**Sent:** 24/08/2021 3:53:19 PM  
**Subject:** 8 Delecta Avenue, Clareville DA2021/1032  
**Attachments:** 8 Delecta Ave, Clareville objection letter #2.pdf; Architect's report 21\_08\_23 B submission copy.pages.pdf;

**DA2021/1032, Lot 20 DP 13291 - 8 Delecta Avenue, Clareville  
Alterations and additions**

**OBJECTION TO DEVELOPMENT APPLICATION DA2021/1032**

Alterations and Additions to a dwelling House  
at Lot 20 in DP 13291  
8 Delecta Avenue  
Clareville NSW 2107

PROPOSED LANDSCAPE AREA  
(with complying driveway)

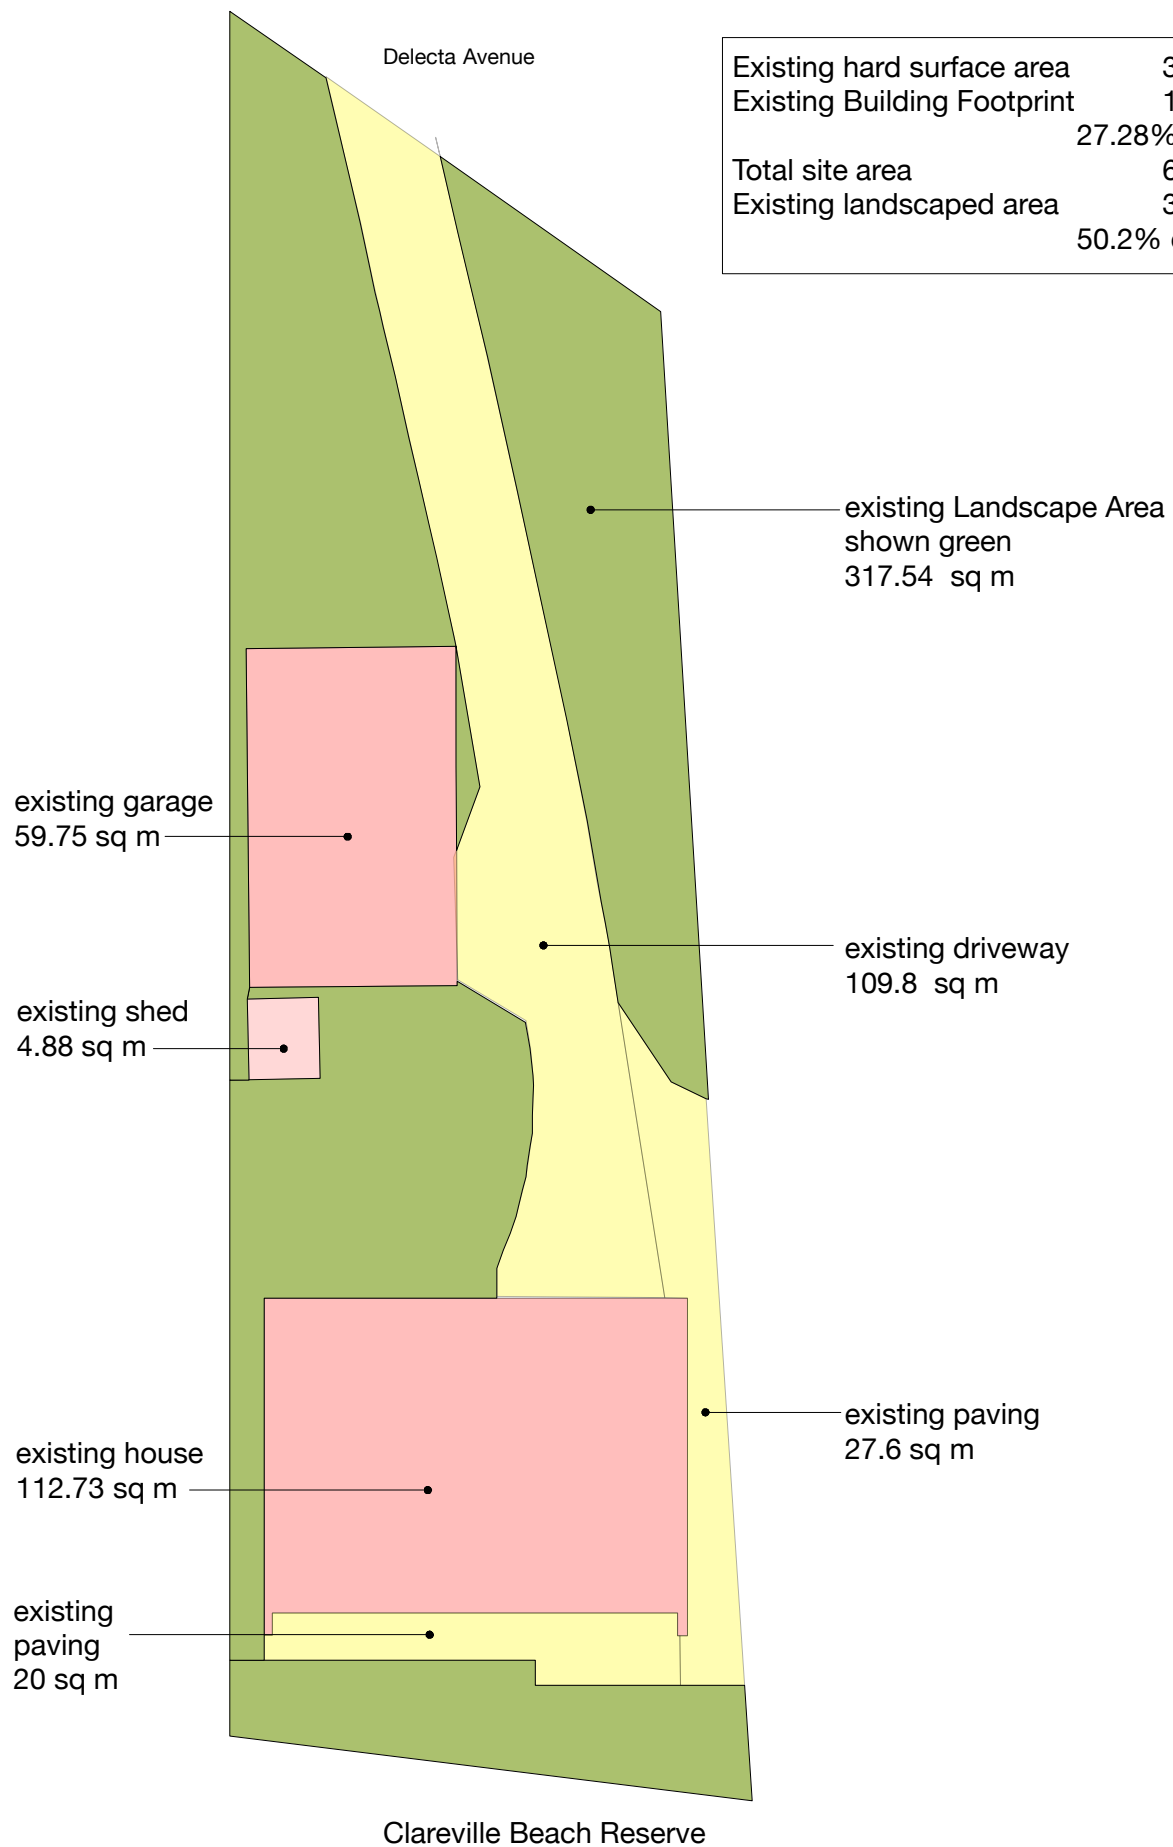
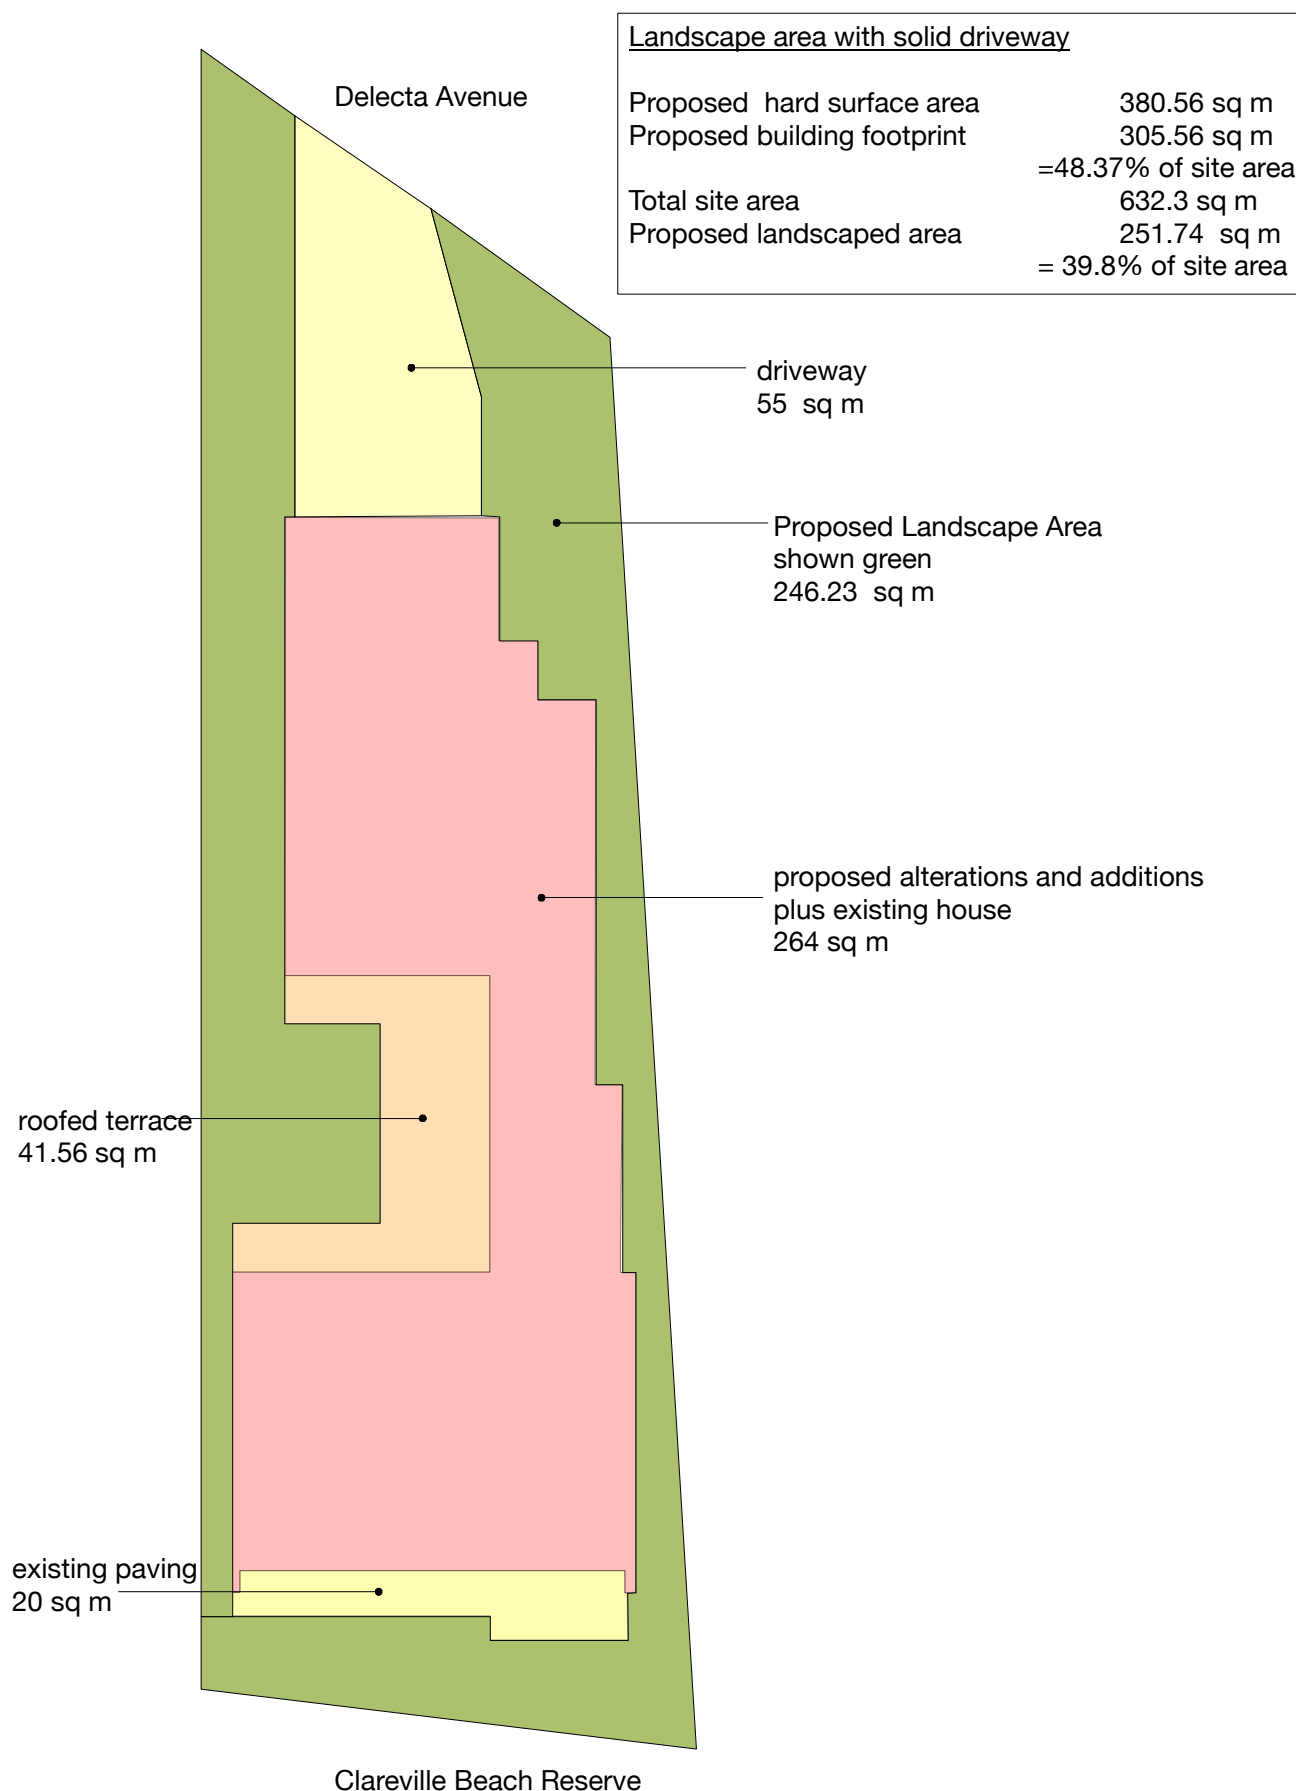
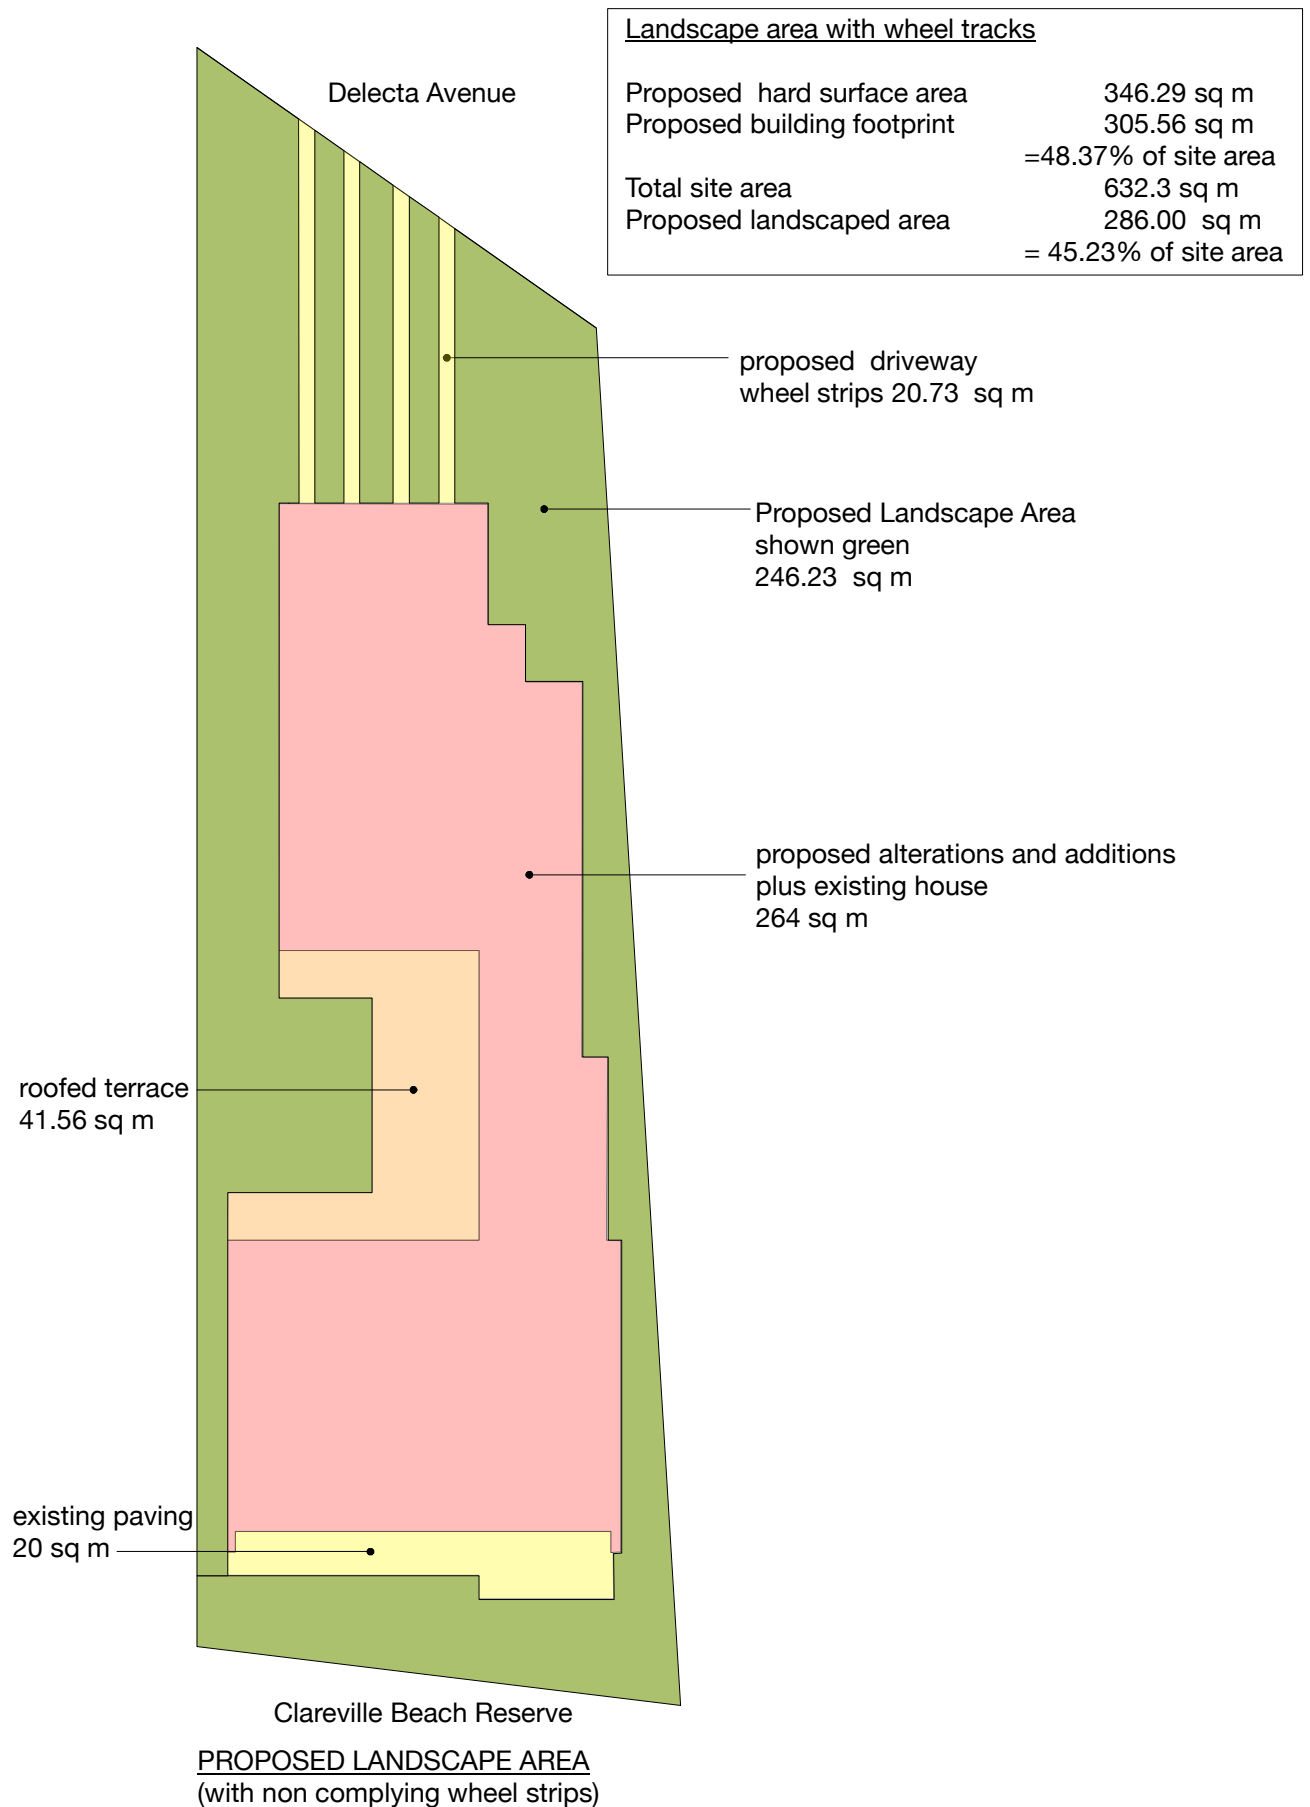
Table 1 shows the Landscape Area calculations for the existing site, and the proposed alterations and additions for this report, in the form required by Clause D1.15 of the DCP. (See also Appendix 1). These are compared with the Landscape Area figures stated in the DA (page 11).

The Landscape Area calculations for this report do not include the proposed roof garden as Landscaped Area, as this is not a provision of the DCP as mentioned in D2 above. The calculations in this report include the area of a full driveway in lieu of the wheel strips for the reasons mentioned later in Part E.

.The numerical figures stated for this report have been calculated from figured dimensions shown on the DA drawings and the site survey, and are independent of the areas quoted on the drawings and in the S.E.E.

That the proposal is re-visited and re-submitted in a form where the Landscape Area is 60% of the site area, measured in accordance with the provisions of the DCP, without a roof garden being counted as Landscape Area, and with a complying driveway included in the design calculations.
